PETITION NO: D2. Z-21-1244885 (2021-2638)

Z-21-1244885
RECOMMENDED CONDITIONS
3795 N. DRUID HILLS ROAD
(January 2022)

STAFF ANALYSIS

Case No.: Z-21-1244885 **Agenda #:** D1

SHEET NUMBER:
C-2.0

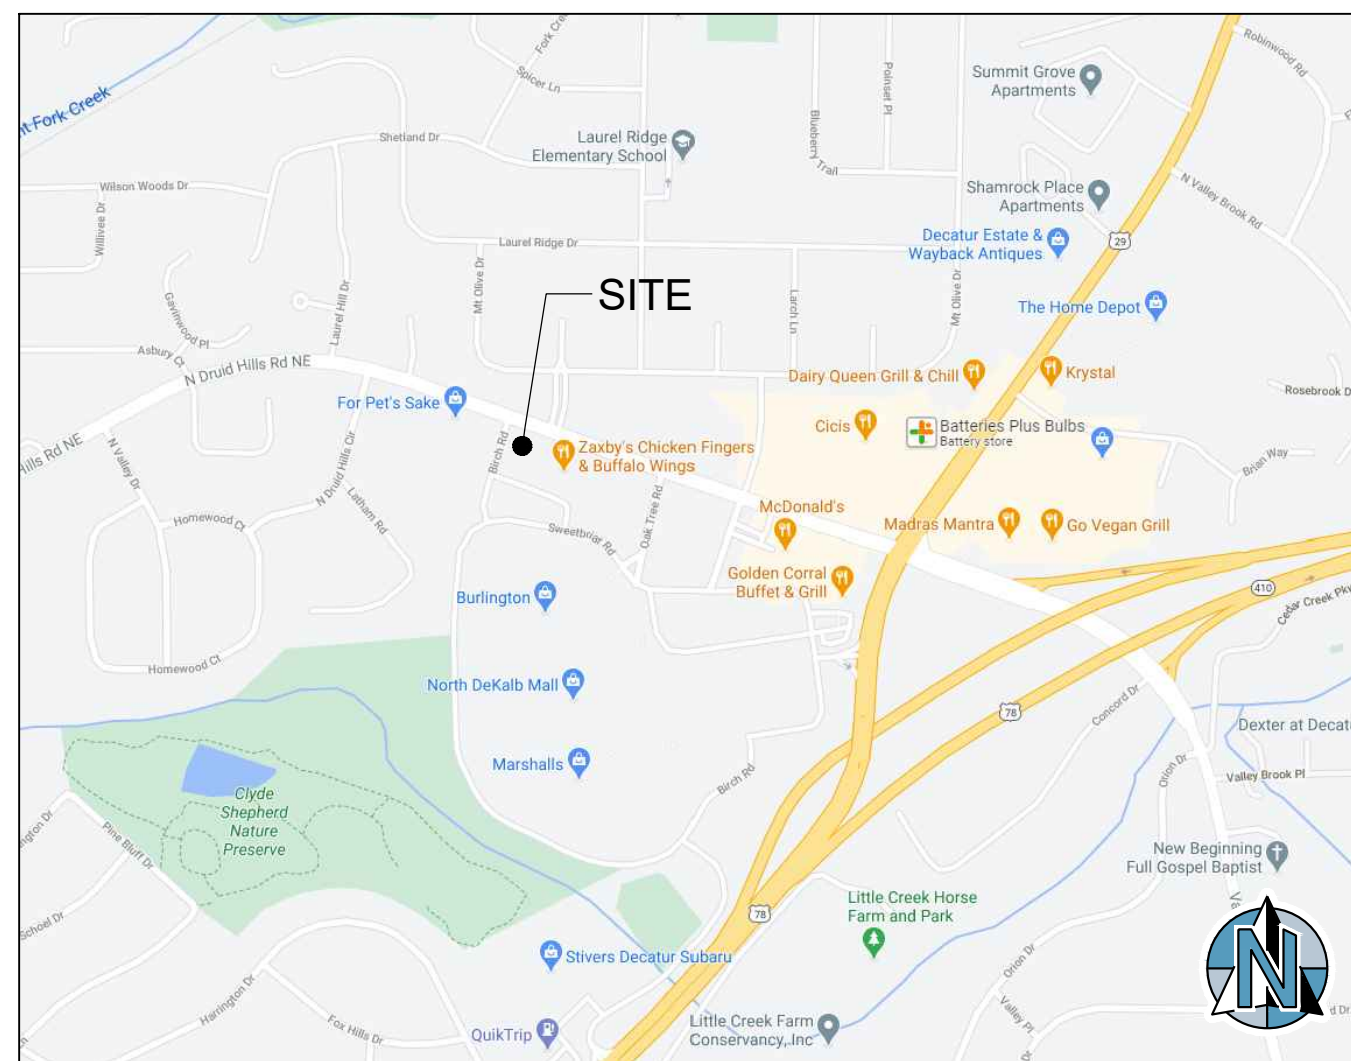
N1 & N2 (Z-21-1244885 & SLUP-21-1244886) - North Druid Hills is classified as a major arterial. Required to add a left turn lane onto Birch. Drive on North Druid Hills limited to Right in/right out only. Please see chapter 5 of the zoning code and chapter 14-190 of the land development code for infrastructure requirements. Requires 10 foot landscape strip, bike lanes and 6 foot sidewalks or 10 foot multiuse path (preferred), street lighting on back of sidewalk. Right of way dedication of 50 feet from centerline or such that all public infrastructure is within county right of way, whichever greater. Birch Road is classified as a local street. Requires a 27.5 foot right of way dedication from the centerline or such that all public infrastructure is on county right of way. Due to the proximity of the mall, potential for redevelopment and connectivity the residential areas- a 10 foot multiuse trail to be included in the sight design along Birch. Requires a 6 foot landscape strip. Streetlights required on back of path.

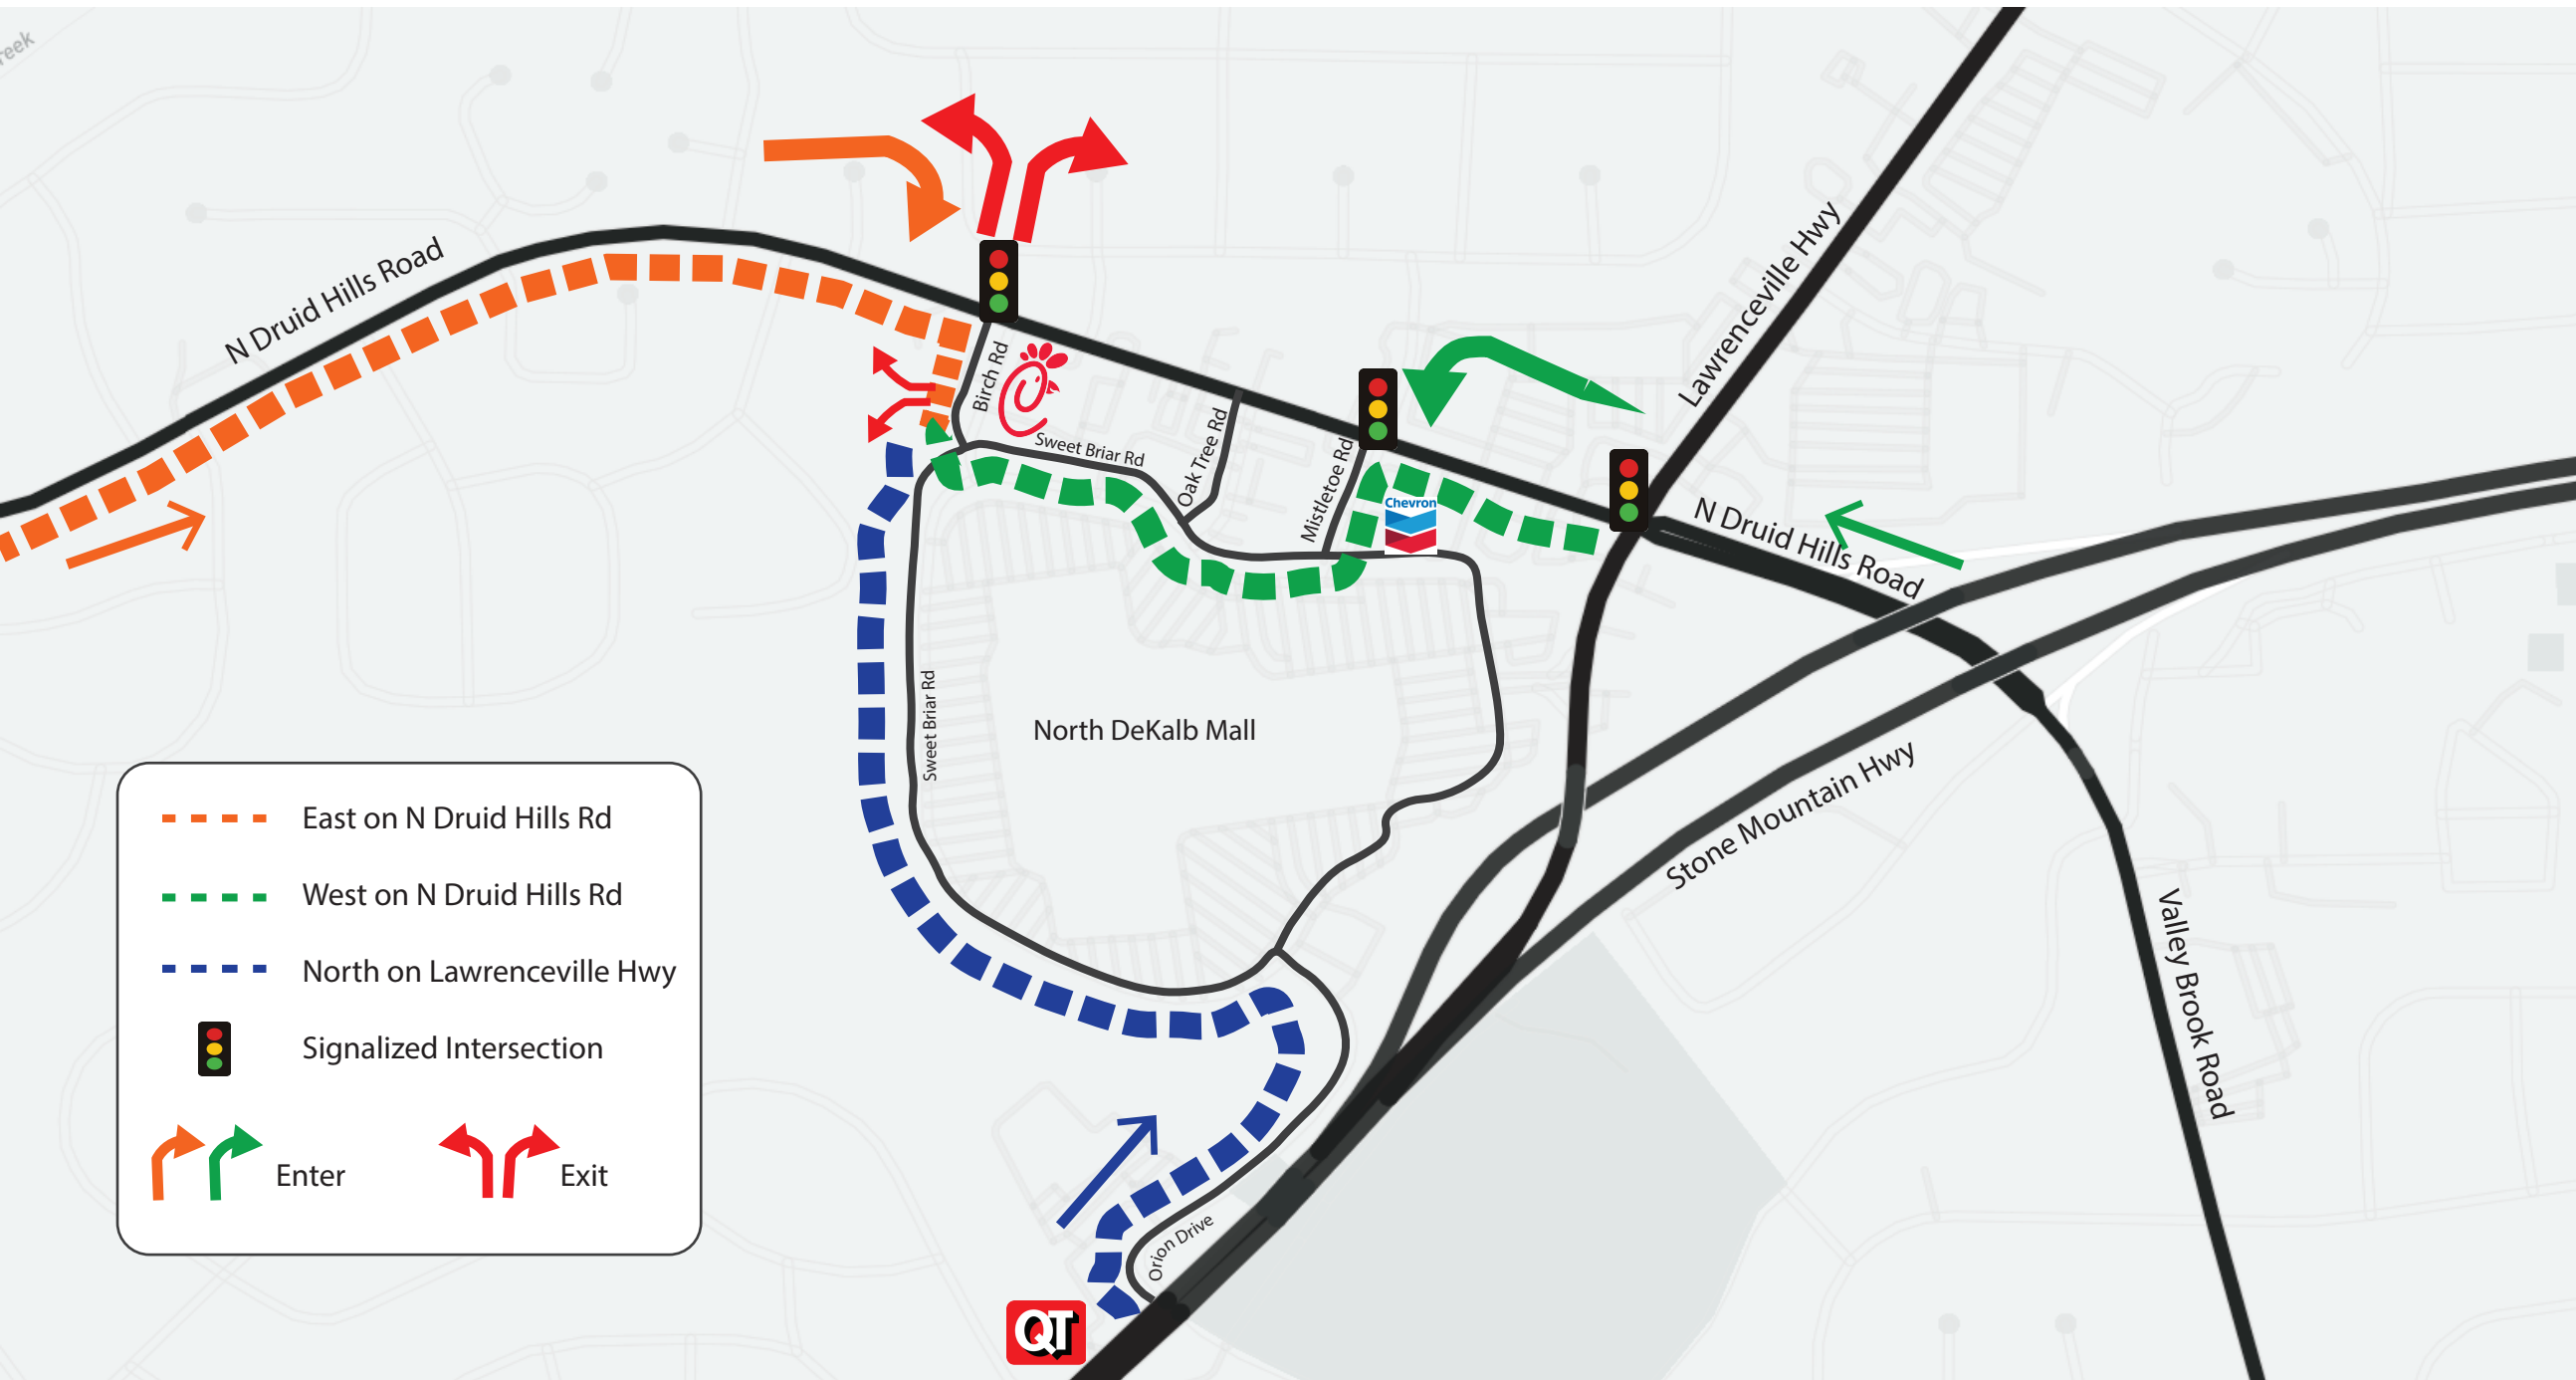
ADDED CLEAR TRANSOM WITH FROSTED SPANDREL GLAZING BELOW

ADDED FROSTED SPANDREL GLAZING

ADDED NEW OPENING. CLEAR TRANSOM WITH SPANDREL GLAZING BELOW

ADDED FROSTED SPANDREL GLAZING

ADDED CLEAR SPANDREL GLAZING
